Document Reference	IC02-INT-EC-OFL-010-INC-RPT-008	Revision	01
---------------------------	---------------------------------	-----------------	----

Inch Cape Offshore Transmission Works - Additional Landfall Works

Marine Licence MS-00010672 Variation Application Report

Figure 2.1: Proposed revised additional landfall works design for the Inch Cape Offshore Wind Farm export cable landing

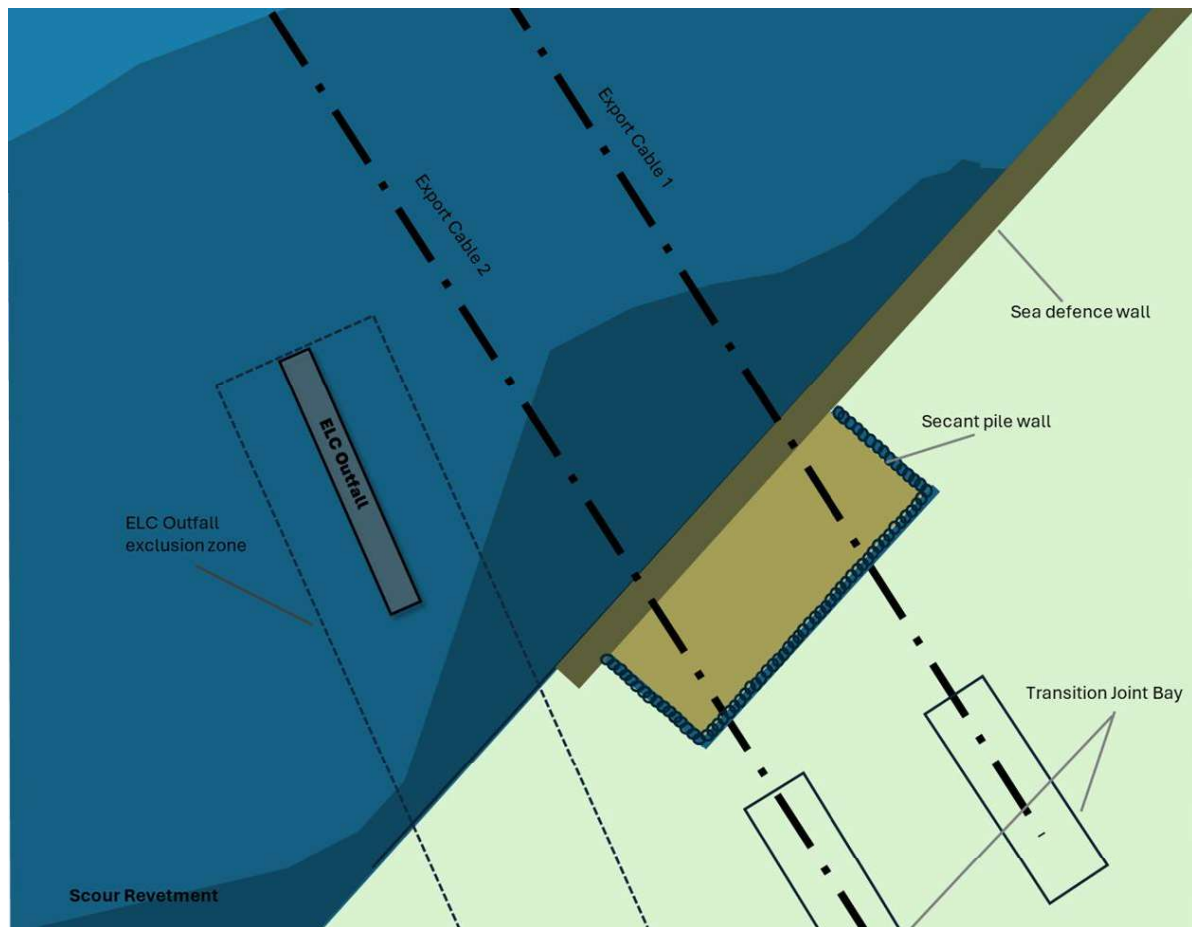
16 As discussed in section 1.2, the refined design solution proposes a reduction to the existing licenced activities, as it avoids the need for an offshore cofferdam and ELC Outfall removal/ reinstatement. Minor changes to the layout and methods for the seawall removal and reinstatement licenced under the Additional Landfall Works are proposed, as shown detailed in Figure 2.1 and Table 2.1.

Item	Revised additional landfall works design details	How it compares with previous design (20 th September 2023 Application)
Seawall & Rock Revetment Works	Installation of an onshore secant pile cofferdam. This activity is permitted through a separate planning permission.	The previous design proposed using an offshore cofferdam, which is no longer required. The offshore cofferdam was permitted through a separate Marine Licence.
	Rock armour and concrete blocks will be removed in front of the section of existing sea defence wall that needs to be removed. The materials removed will be stockpiled at the intertidal zone or onshore, to be re-used for reinstatement at later stage if suitable	No changes to previous design/ methods.
	It is anticipated that approximately 24 m of continuous sea defence wall will be removed. The total length of seawall may vary, as it ultimately depends on the integrity condition of the existing structure, and final detailed survey to determine joints location.	The previous design estimated a total of 21 m of sea wall defence to be removed. At the time, it was acknowledged that there was a risk that removal of one panel may result in a breakout a 10 m section of wall bringing the maximum length of seawall to be removed and reinstated to 24 m. The new design has been revised to anticipate the need for wider removal.

The sea defence wall will be reinstated, consisting of a gravity structure using precast reinforced concrete structure. The new sea wall will allow for two portals, where the export cables will pass through towards the transition joint bay onshore. The annulus between the cable protection system and the portals will be grouted and sealed to not provide a flow path. During construction, and prior to installation of the duct, the portals will be temporarily capped.	The previous reinstated wall design included two precast letterboxes to allow the installation of two precast concrete troughs/ U-ducts and temporary stoplogs/moveable gates used as necessary. The concrete troughs/U-Ducts are no longer required in the revised additional landfall works design. A cable protection system will be installed instead, which will form part of the scope licensed under the OFTI Marine Licence.
